# **MONITORING YEAR 5 ANNUAL REPORT**

## **CROOKED CREEK #2 RESTORATION PROJECT**

DMS Project Number 94687

RE: Crooked Creek II Mitigation Site -Year 5 Monitoring Report  
Final Submittal for DMS  
DMS ID 94687  
DEQ Contract Number D09126S  
Yadkin Pee-Dee River Basin – CU# 03040105; Union County, NC

**Recorded In-stream Flow Events**  
Crooked Creek #2 Restoration Project  
DMS Project No. 94687  
Monitoring Year 5 - 2020

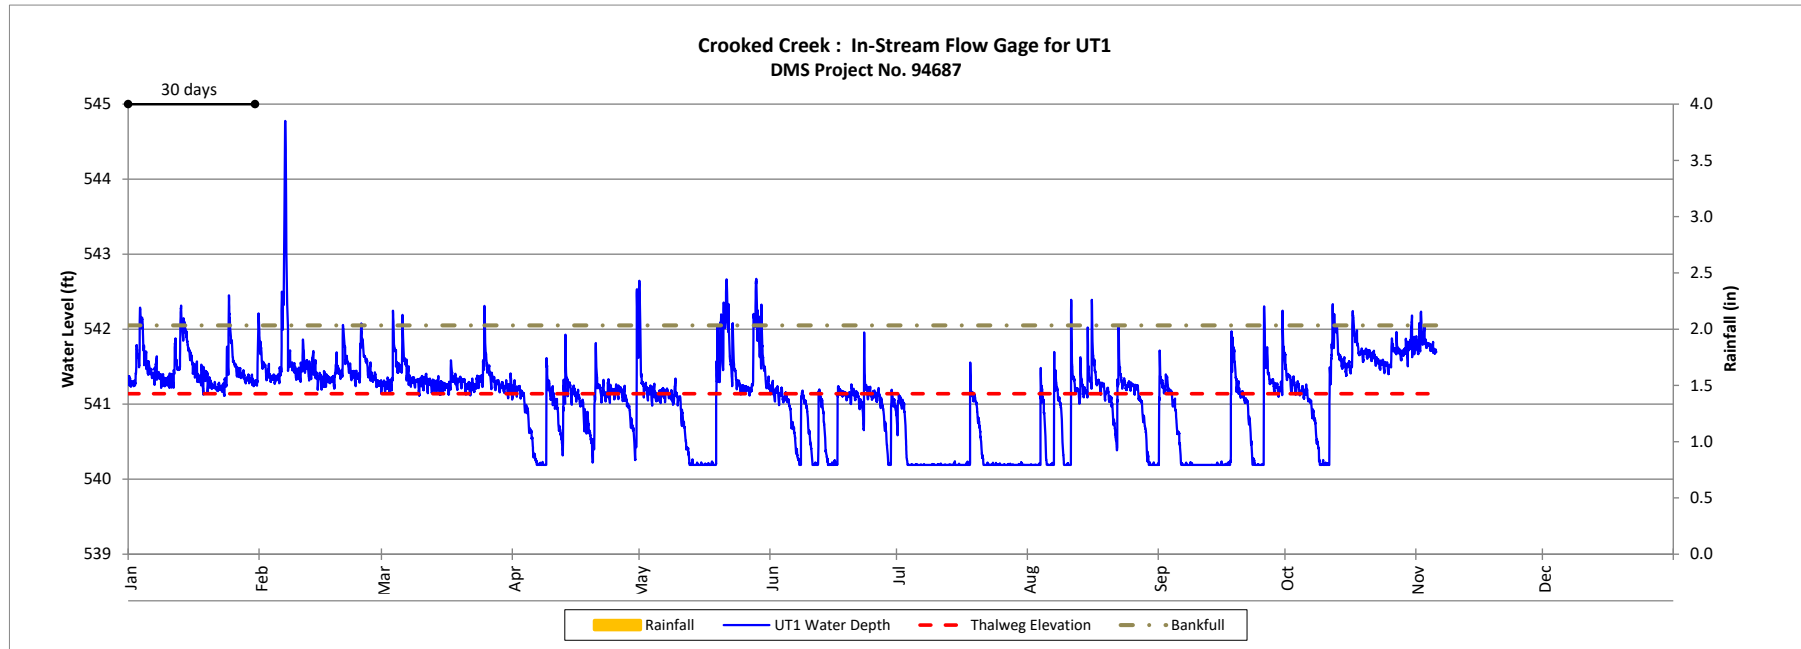
**DMS Comment; Continuous flow gauge graph for UT1 appears to be missing.**

**DMS Comment; The in-stream flow gauge files is corrupt, please check this file to ensure it is working, and resubmit.**

*Wildlands Response; Wildlands has updated Appendix 5 to include flow gage for UT1.*

*Wildlands Response; Wildlands has inserted a new file that is working. Please let us know if you additional issues with this file.*
